**RE: Development Application Number DA0762/2020**

**Address of Development 19A Canning Street Launceston (CT179294/2)**

Residential – Construction of a dwelling  
19A Canning St – Launceston, TAS 7250

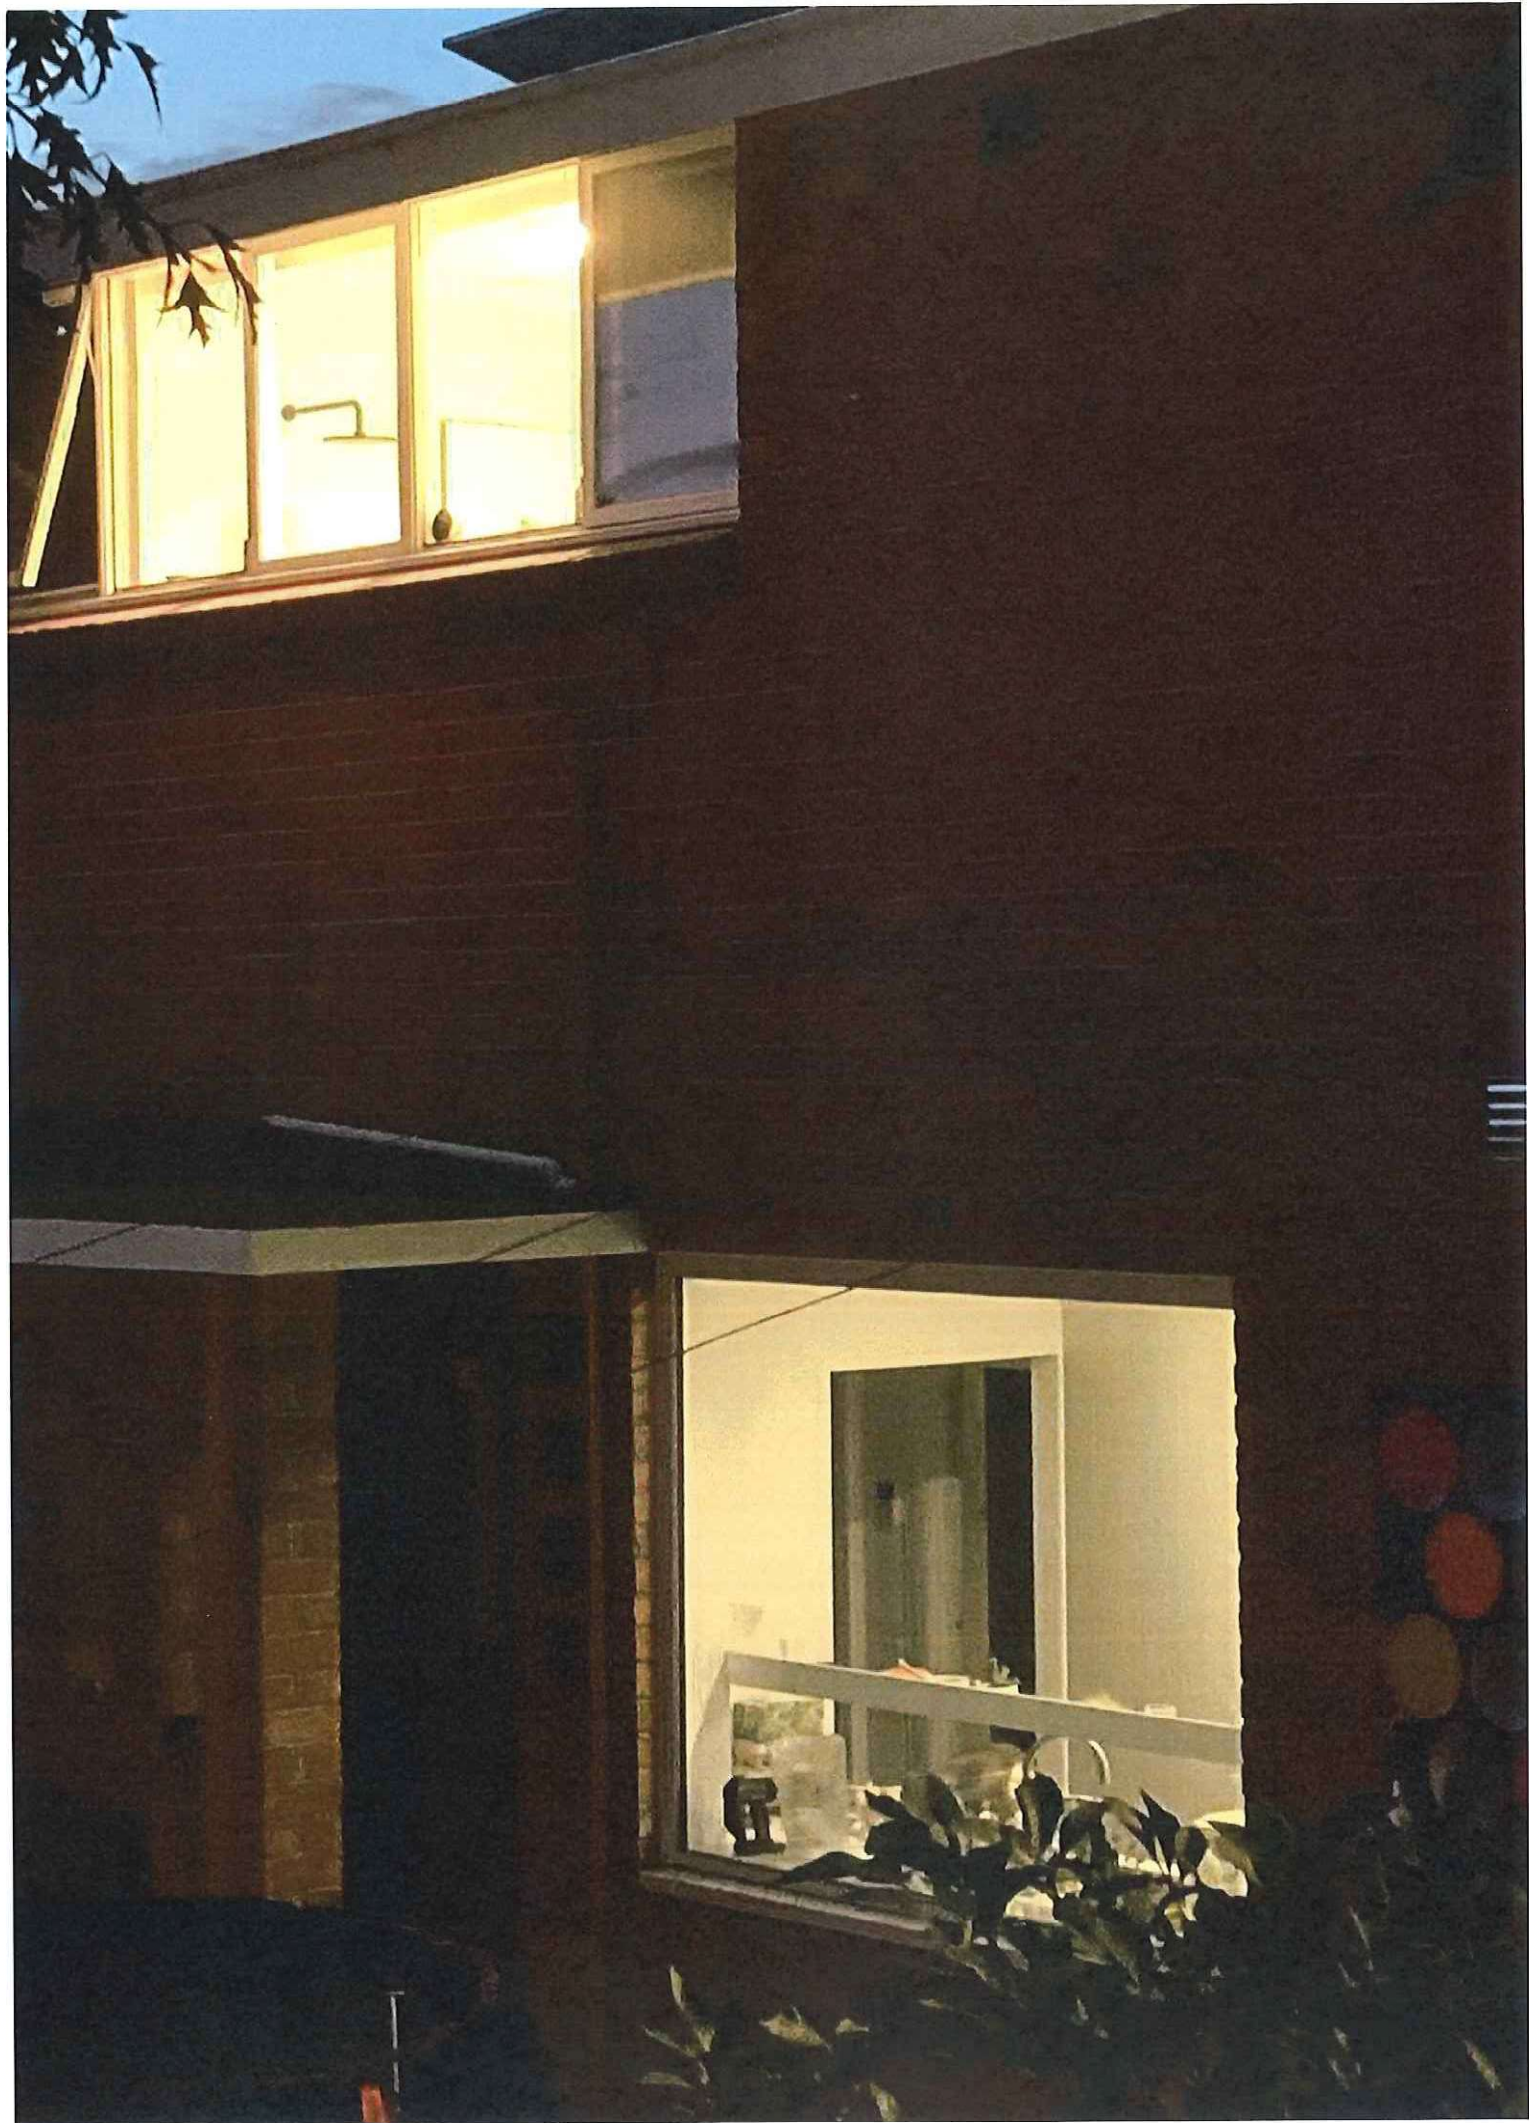
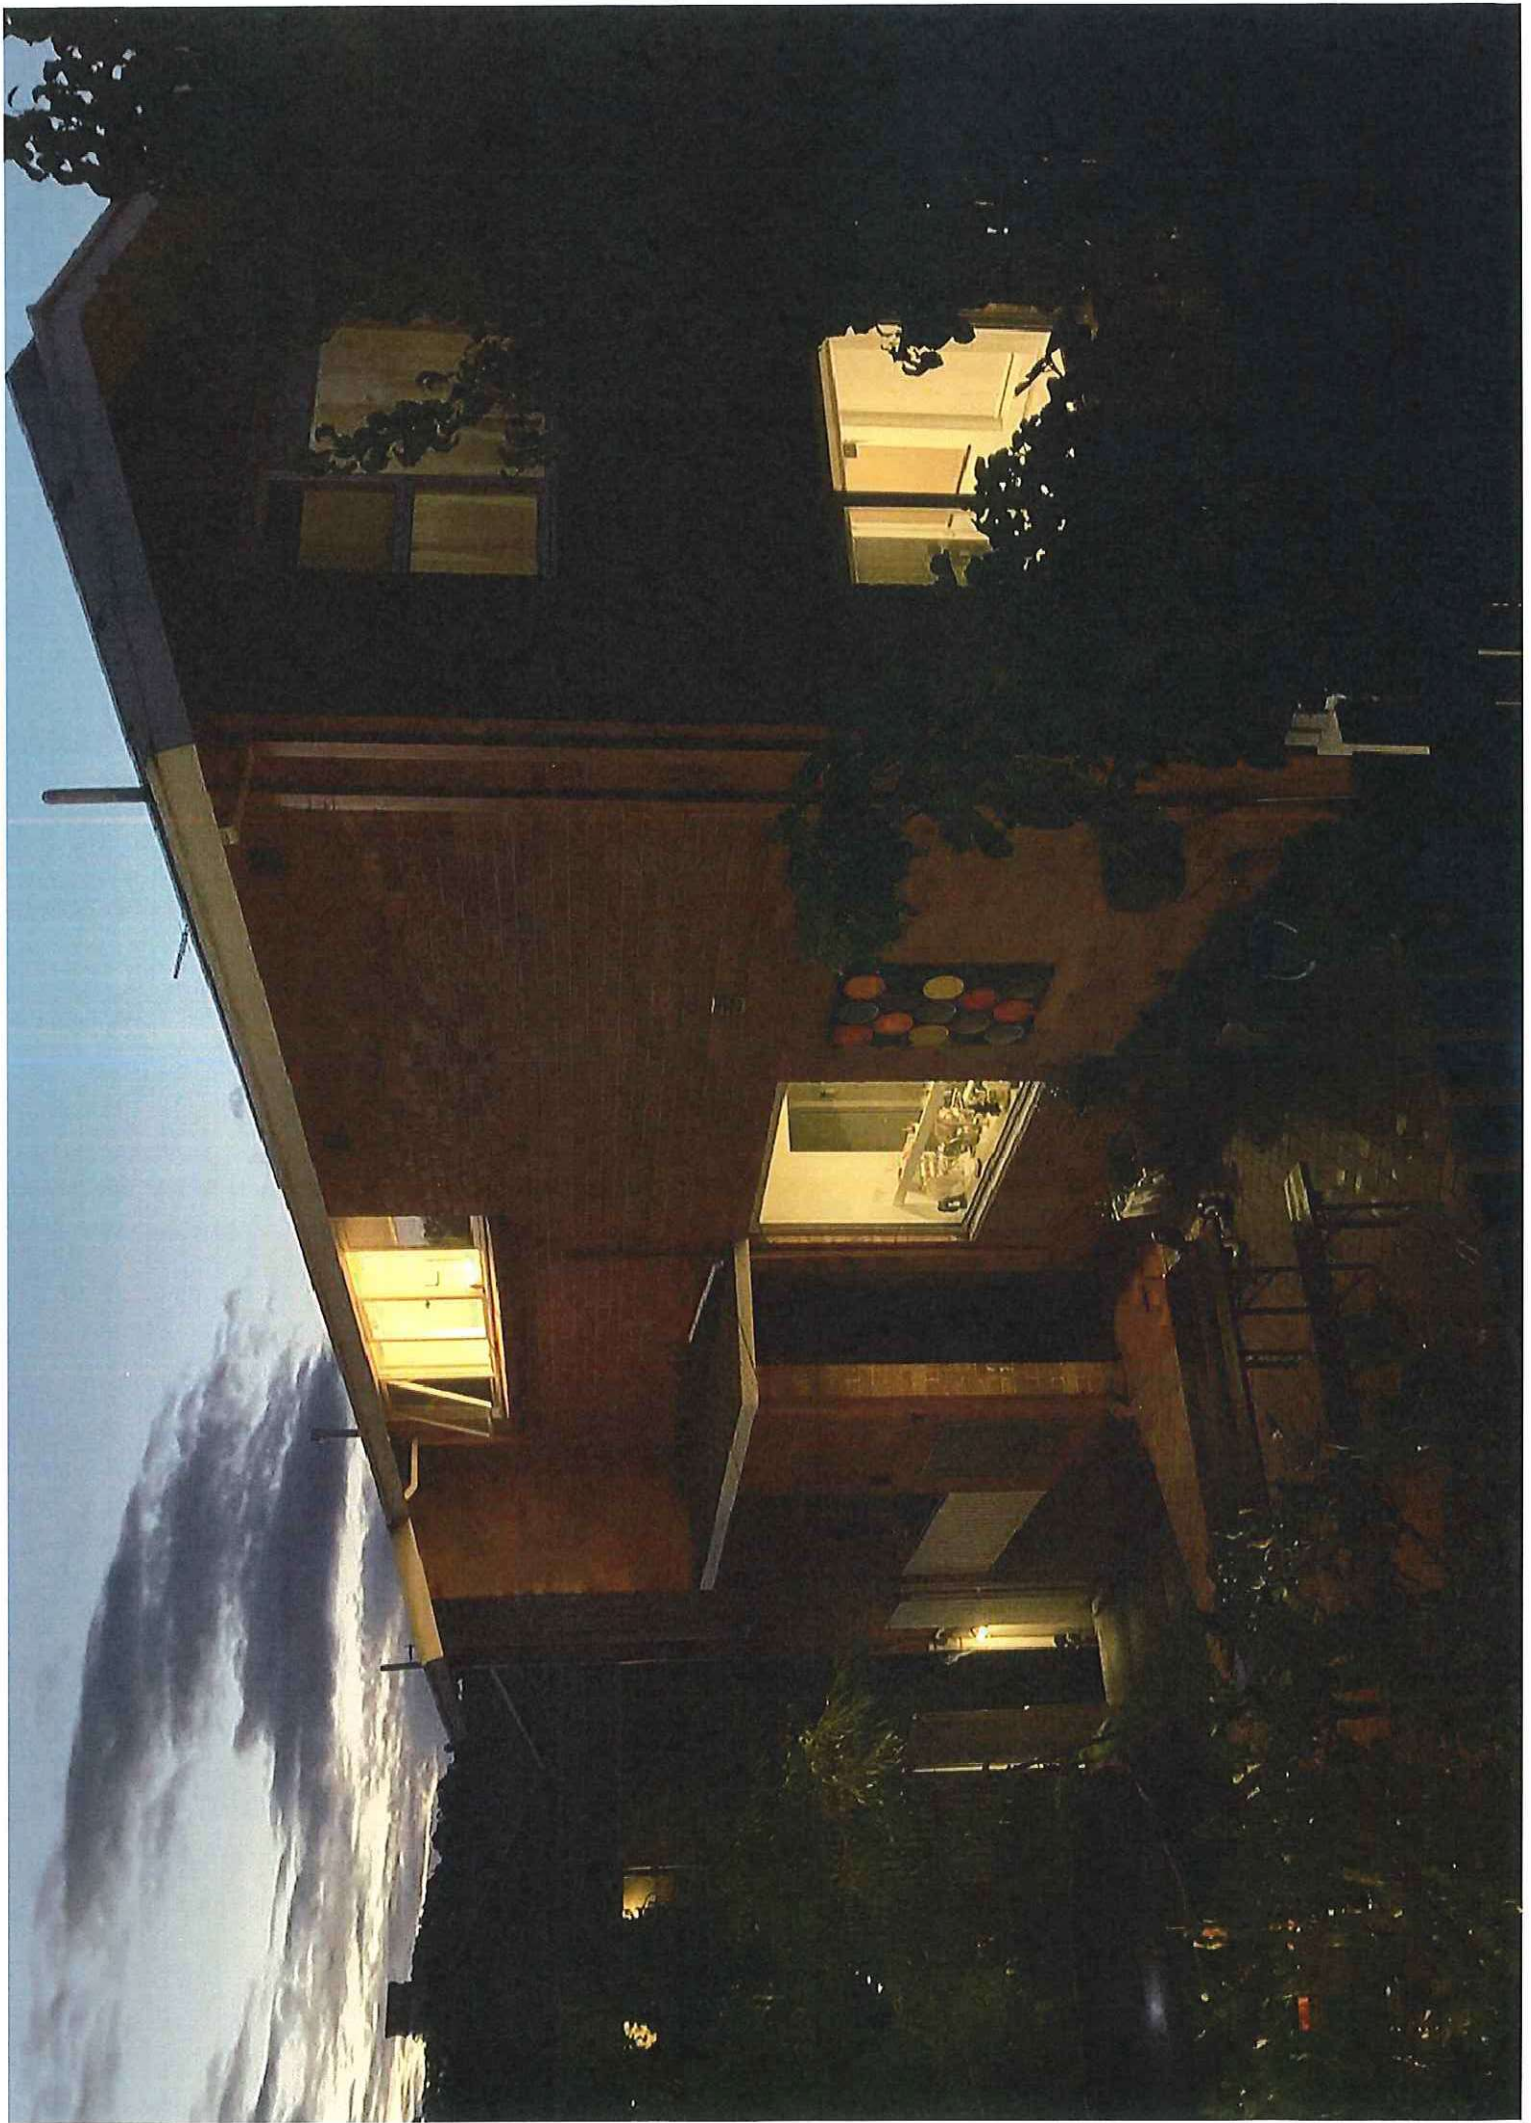
**Please refer to the attached images 1a and 1b.** which show the proposed view from our kitchen before and after the addition of the proposed residence.

**Please also refer to image 2 & 3** which indicate the overlook into our private outdoor space which were taken from the approximate location of the proposed deck area. These images were taken from a height of 3.2m from current ground level but the actual viewing height would be around 1.3-1.5m higher, making the overlook even more significant than shown by these images.

**Please refer to Image 4** which shows the approximate view from Window W12, as viewed from the kitchen while preparing food and washing dishes, both standing actions, not seated as suggested in

**Image 1a** - Shows the current view from our kitchen window which is a continuous layering of plants into the near distance.

**Image 1b** - Shows the same view with the approximate location of the proposed development and the level of exposure and overlook that we will be subjected to should it proceed in its current arrangement.

**Image 2** – A view from the approximate location of the proposed deck and entertainment area. Please note that this image is taken at a measured height of 3.2m from current surface level which is 1.3-1.5m lower than the natural standing height of someone standing on the proposed deck area. This difference will obviously make the overview more significant.

**Image 3** – A night time version of the previous image which clearly shows the level of visibility into our interior private spaces.

**Image 4** – A view from the approximate location of Window W12 which shows the clear line of sight from the proposed kitchen area into our upstairs bathroom and main kitchen window.
